STAFF RECOMMENDATION 1905 Boscobel Street March 15, 2017

Application: New construction—detached accessory dwelling unit; Setback determination

Description of Project: Application is to construct a detached accessory dwelling unit (DADU) at the rear of the lot. The structure requires a rear setback determination from twenty feet (20') to five feet (5').

SITE PLAN

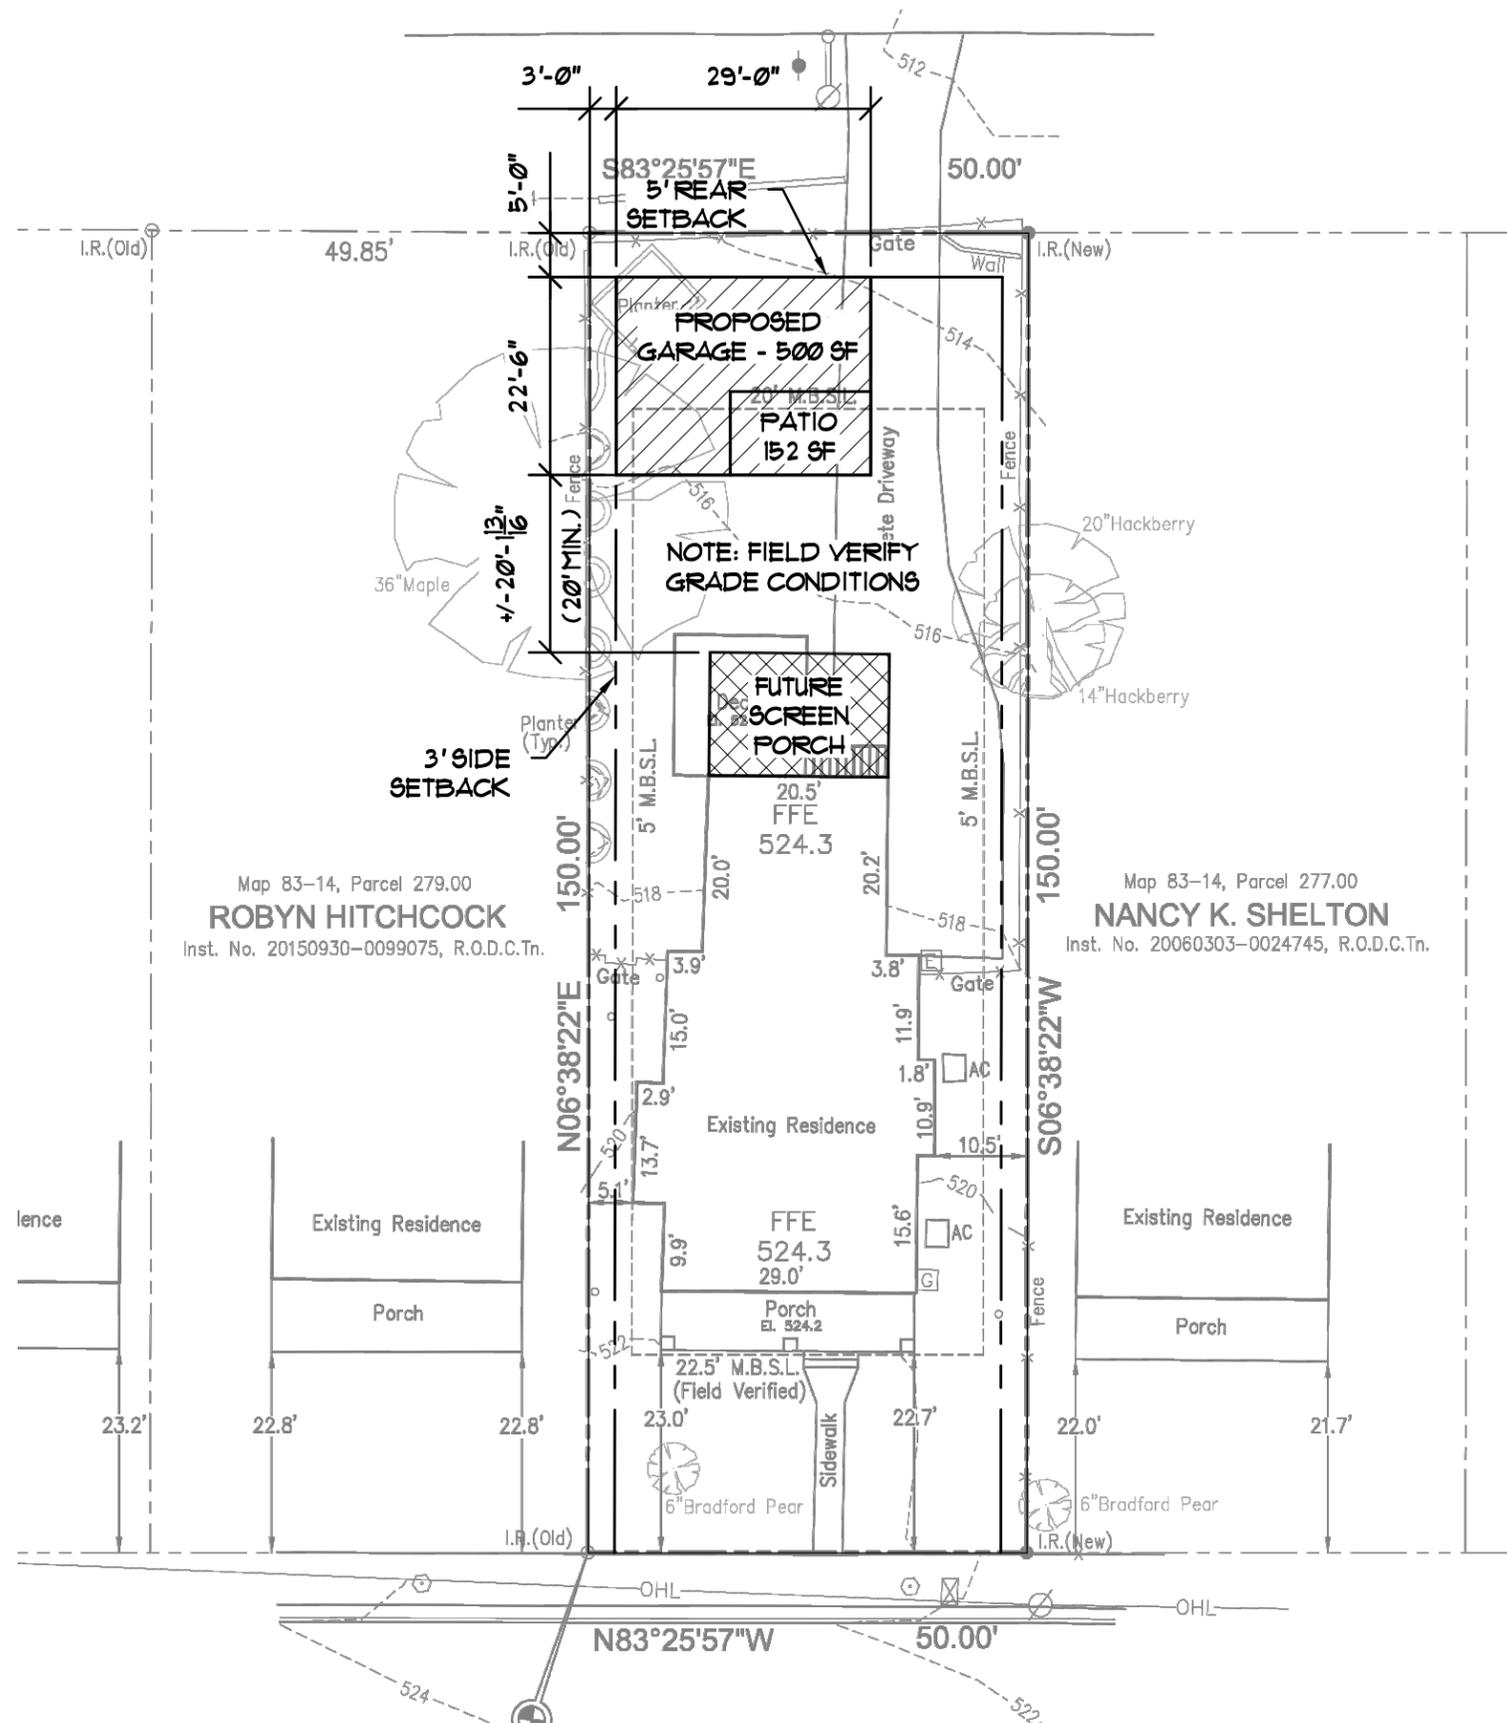
MINIMUM	PROPOSED
Space between principal building and DADU/Garage	20'	Approx.. 34'
Rear setback	20'	5'*
L side setback**	3'	3'
R side setback**	3'	18'
How is the building accessed?	From the alley or existing curb cut	From Lillian Street at rear

Base zoning requires outbuildings with vehicular doors that face a street rather than an alley to be twenty feet (20') from the property line. The applicant is seeking a setback determination to situate the DADU five feet (5') from the rear property line. Staff finds the proposed five foot (5') rear setback to be appropriate for several reasons. Although the rear property line faces a street, rather than an alley, Lillian Street in this location is narrow and does not have any houses that face it. On the north side of the street is Shelby Park and on the south side are the rear yards for houses that face Boscobel (Figure 3). In addition, because of the right-of-way, visually, the DADU will appear to be more than twenty feet (20') from the rear of the property. In addition, outbuildings historically were located close to the rear property lines, as is proposed here. A five foot (5') rear setback is more historically appropriate than a twenty foot (20') rear setback. Lastly, the five foot (5') setback will allow for more space in between the back of the house and the DADU. For these reasons, staff recommends approval of the setback determination and finds that the DADU meets section II.B.8 of the design guidelines and 17.16.30.G. 4 of the ordinance.

EXTERIOR ELEVATIONS

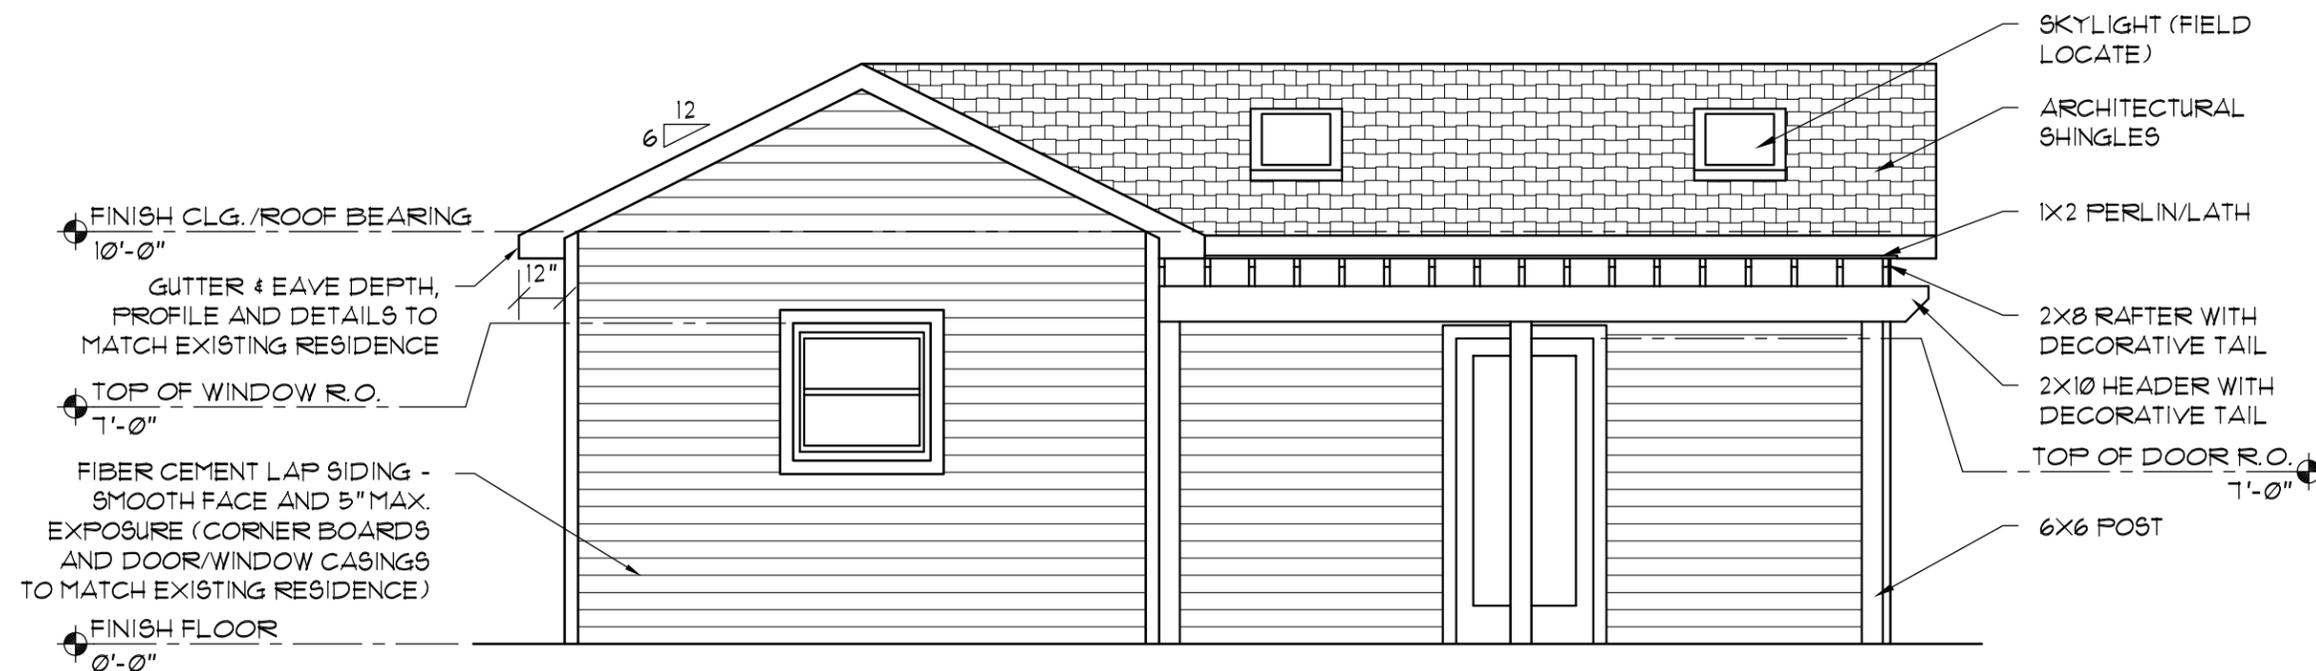
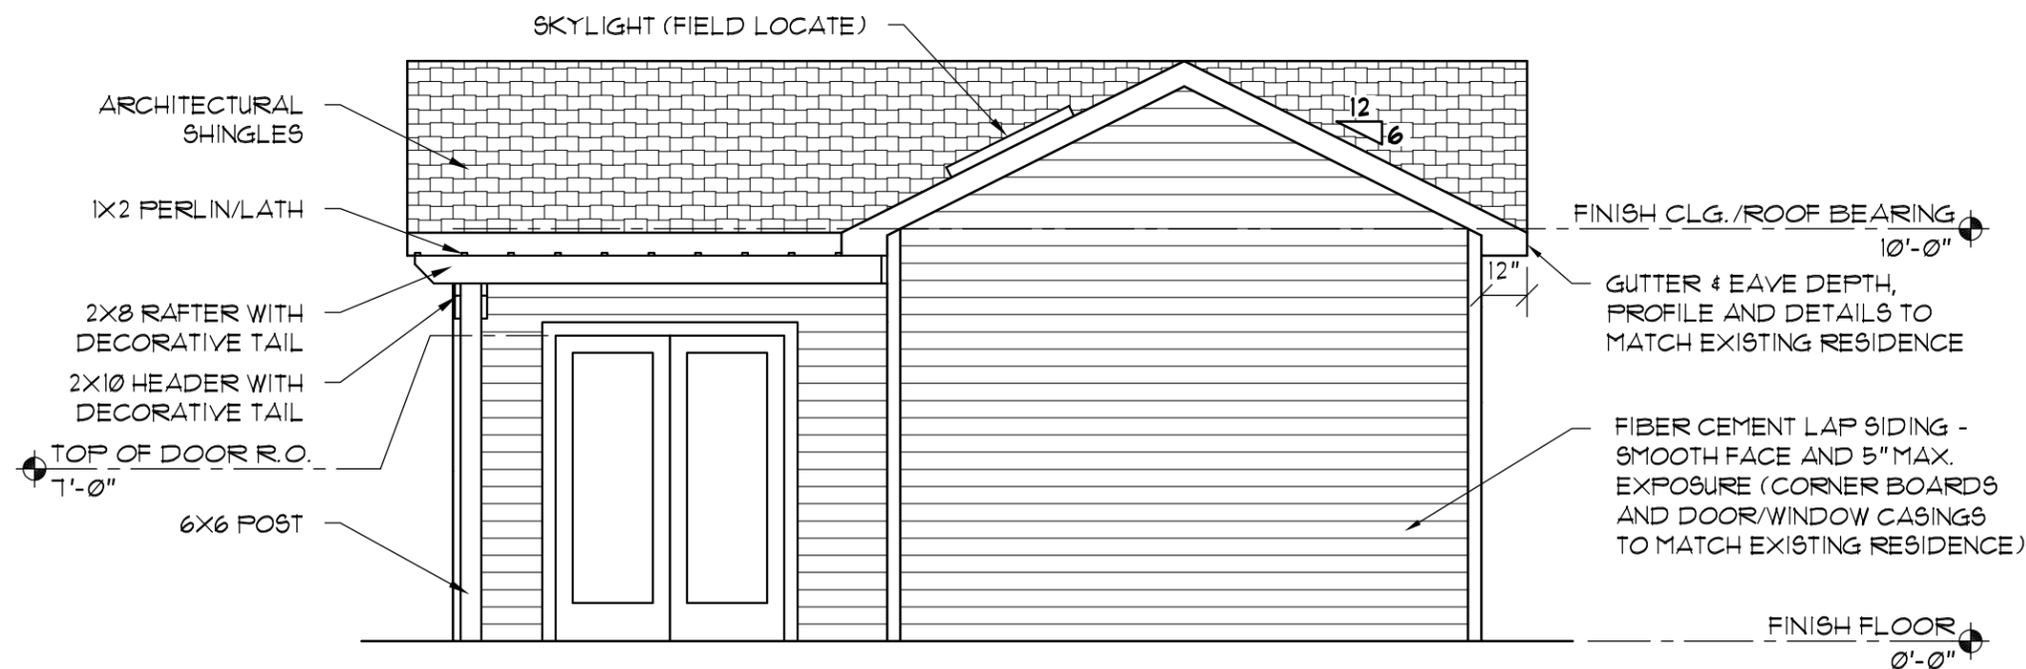
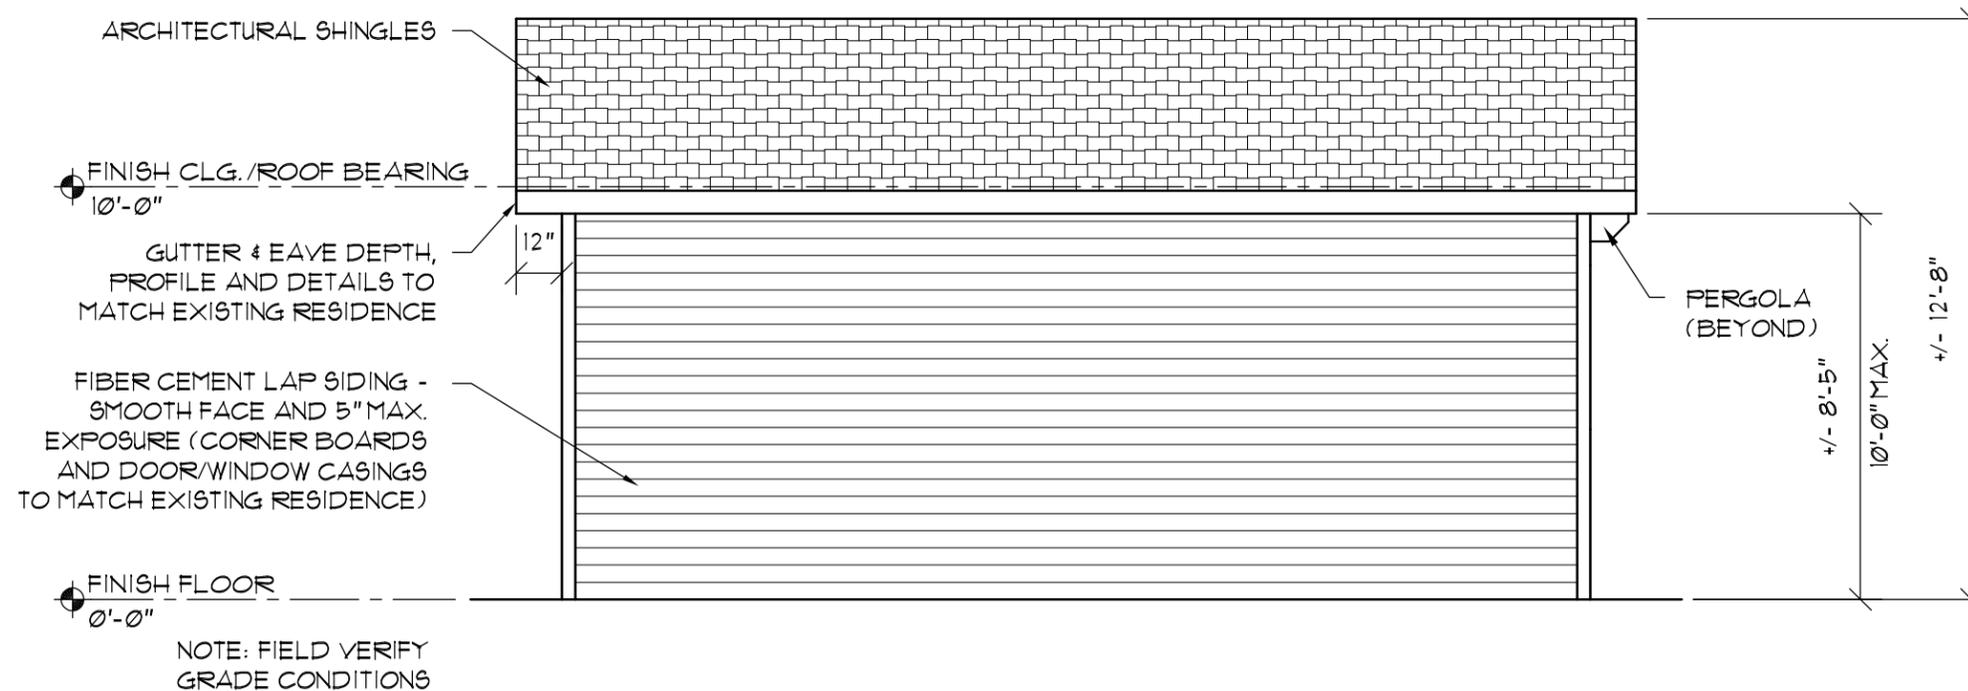
Proposed Element	Proposed Form	Typical of district?
Primary form	Cross-gable	Yes
Primary roof slope	6/12	Yes
Porch form	Flat Pergola	Yes
Porch slope	Flat	Yes

Since the form and slopes are similar to historic outbuildings, staff finds that the DADU meets Section II.B.8 of the design guidelines and section 17.16.030.G.8 of the ordinance.

Design Standards: The accessory structure has a simple, utilitarian design that is appropriate for outbuildings. Its roof form, detailing, and form do not contrast greatly with the primary structure. The fenestration is of a more modern layout, but it is appropriate for an outbuilding. The outbuilding will be visible from Lillian Street, but because it is one-story in height and appropriately scaled and because there are no houses that face this block of Lillian Street, staff finds that the outbuilding will not detrimentally affect the character of Lillian Street. Staff finds that the DADU’s design meets Sections II.B.8 of the design guidelines and Section 17.16.030.G.8 of the ordinance.

Existing conditions (height of historic portion of the home to be measured from finished floor)	Potential maximums (heights to be measured from grade)	Proposed (should be the same or less than the lesser number to the right)
Ridge Height	21'	25'	12'8"
Eave Height	11'	10'	10'

1. Staff approve the final details, dimensions and materials of windows and doors prior to purchase and installation;
2. Staff approve the patio pavers;
3. Staff approve the roof shingle color; and
4. Staff receive a copy of the filed restrictive covenant for the detached accessory dwelling unit prior to issuance of a permit.
